PIRATES BEACH WASTEWATER TREATMENT PLANT REPLACEMENT

Date: 12/3/2021

Subject: Addendum No. 2
Responses to Pre-Bid Questions & Specification & Drawing Modifications

HEADWORKS UPPER LEVEL FRAMING PLAN

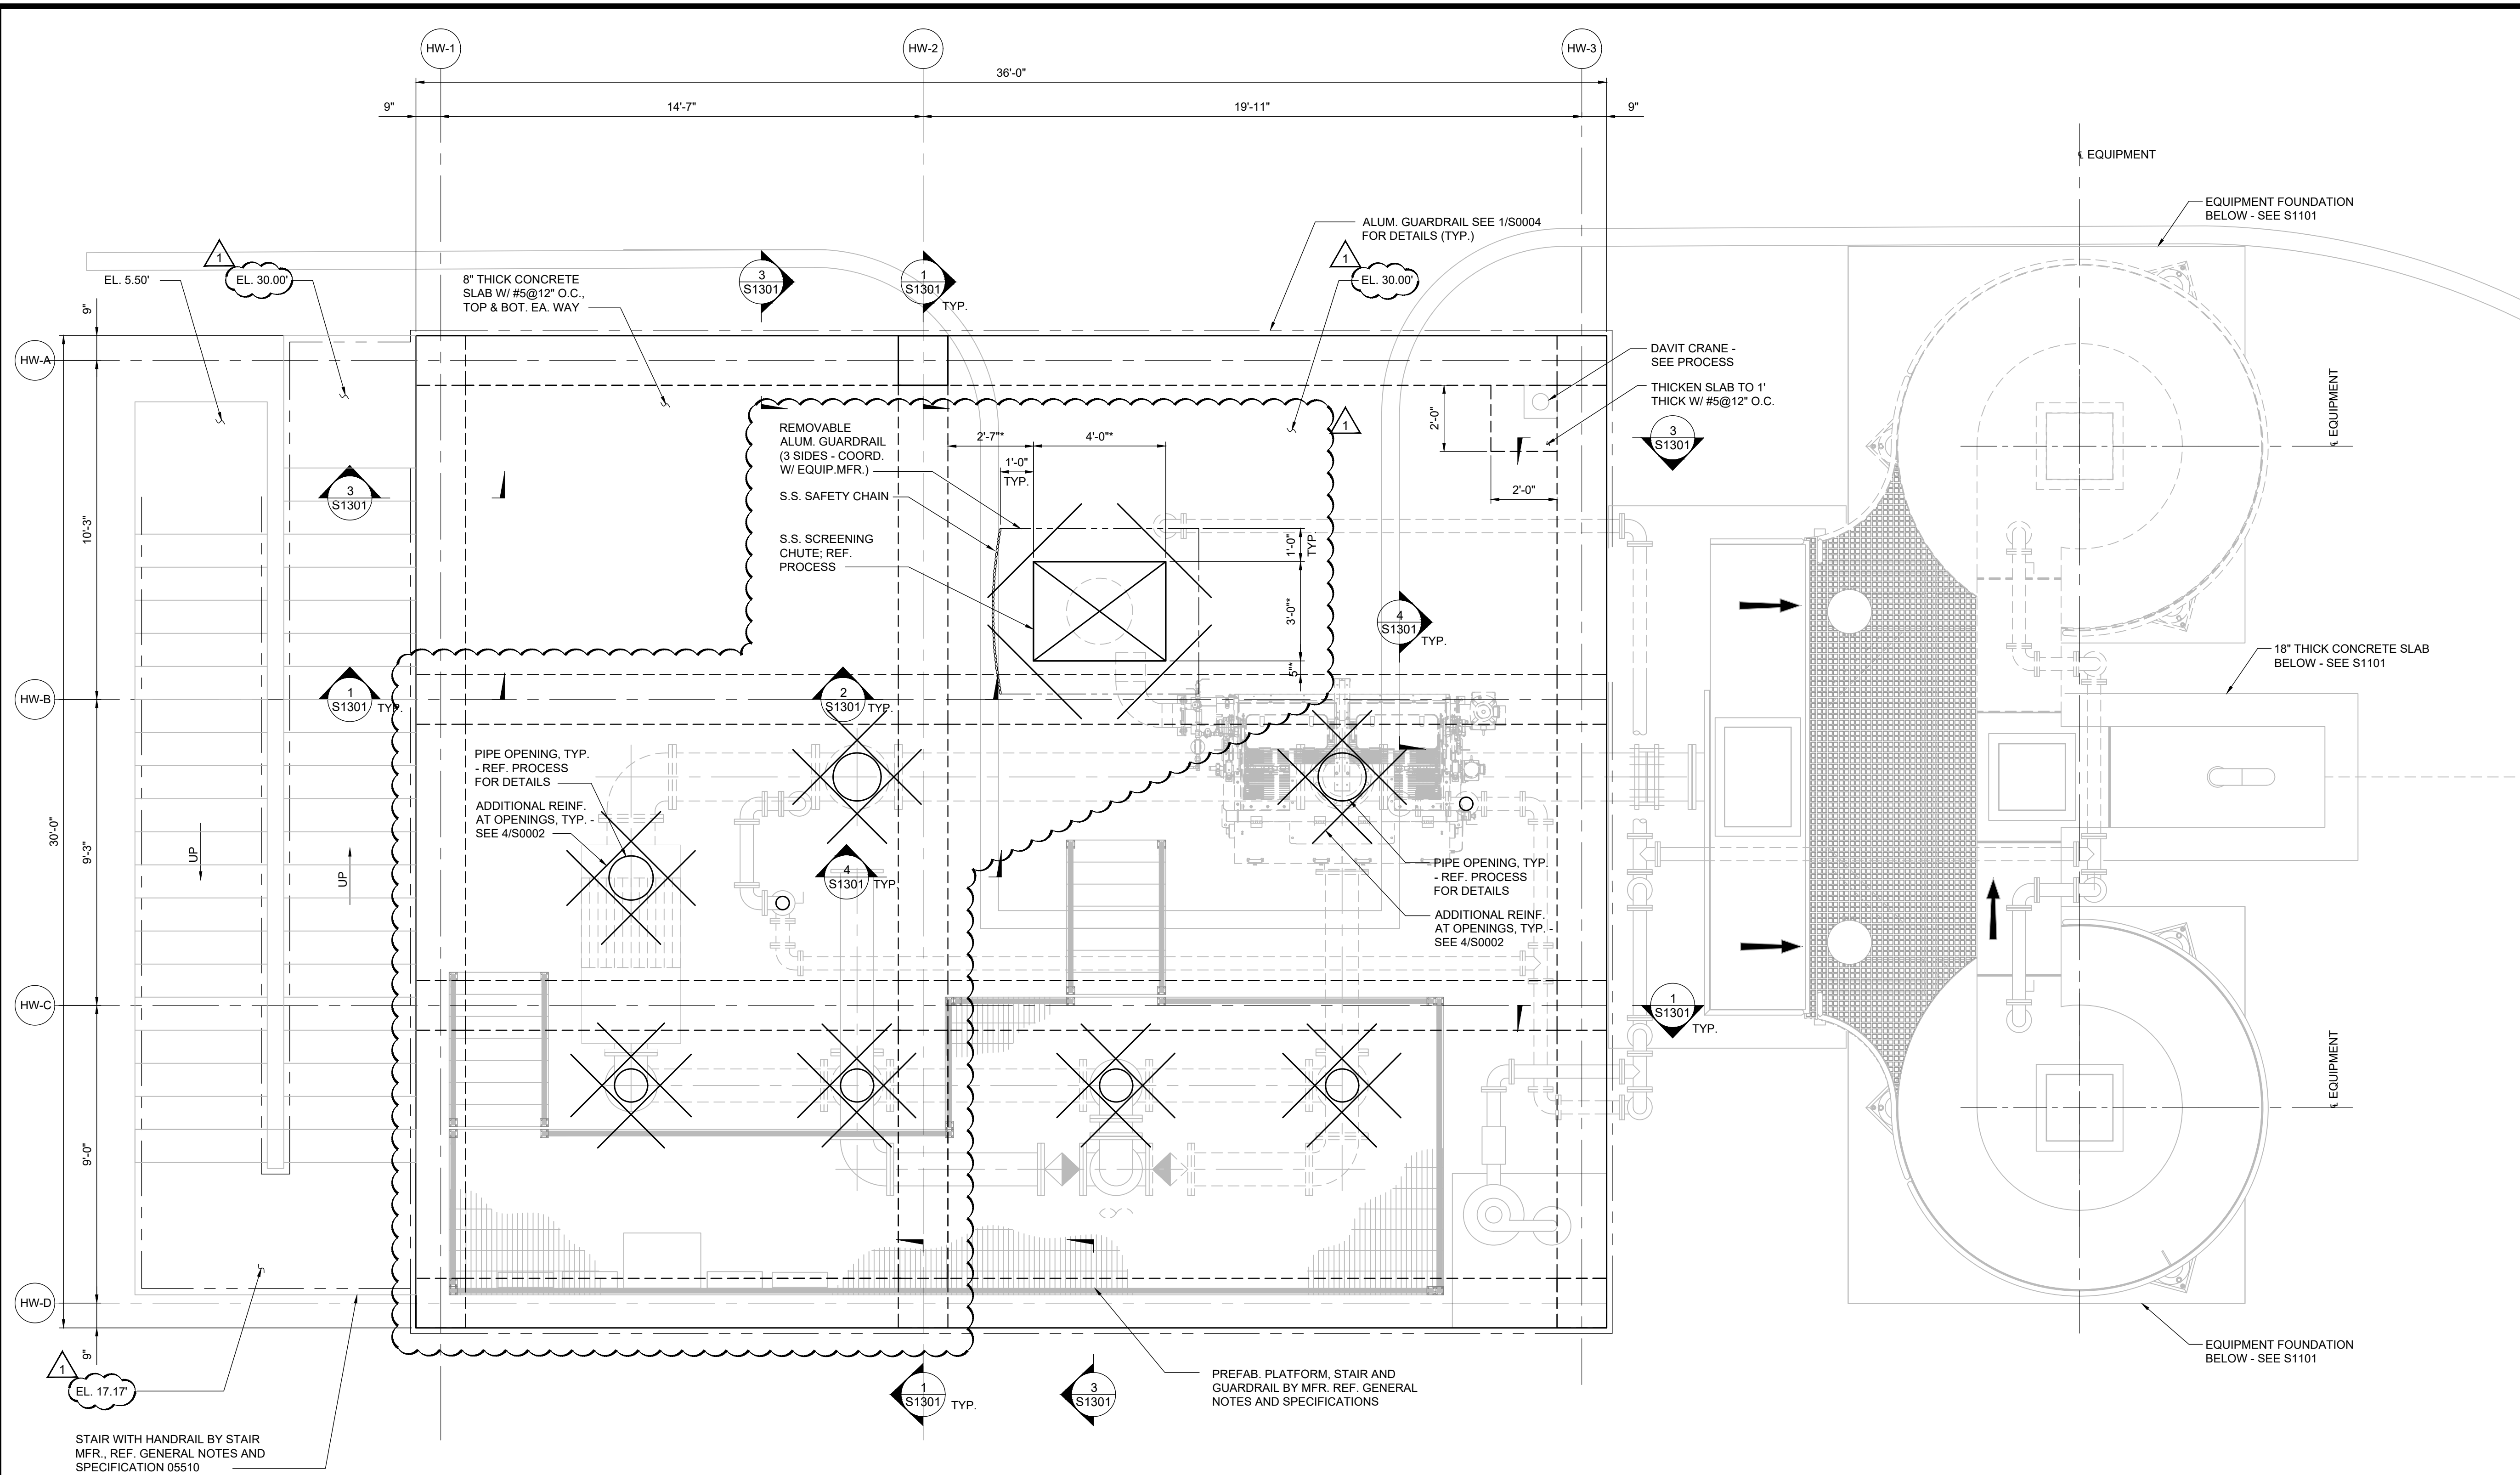
83. Sheet S1301 calls out Top of the Headworks elevated slab is 25.35'. Sheet D1302 calls out top of the Headworks elevated slab is 30'. Please confirm the elevation of the Headworks elevated slab.

Answer: The top of headworks elevation is 30.0 ft (see revised Sheet S1301).

- FOR STANDARD DETAILS, REFERENCE SHEET S0002 THRU S0004.
- TOP OF CONCRETE SLAB ELEVATION EQUALS +30.00'.
- REFER TO THE CIVIL, PROCESS, AND ELECTRICAL DRAWINGS FOR ADDITIONAL INFORMATION NOT SHOWN OR ADDRESSED HEREIN AND FOR SIZE AND LOCATION OF ANY REQUIRED SLEEVES, BLOCKOUTS, EMBEDDED ITEMS, ETC. THE CONTRACTOR SHALL BE RESPONSIBLE FOR COORDINATING THE LOCATIONS AND DETAILS FOR THESE ITEMS PRIOR TO FABRICATION AND CONSTRUCTION OF THE STRUCTURE.
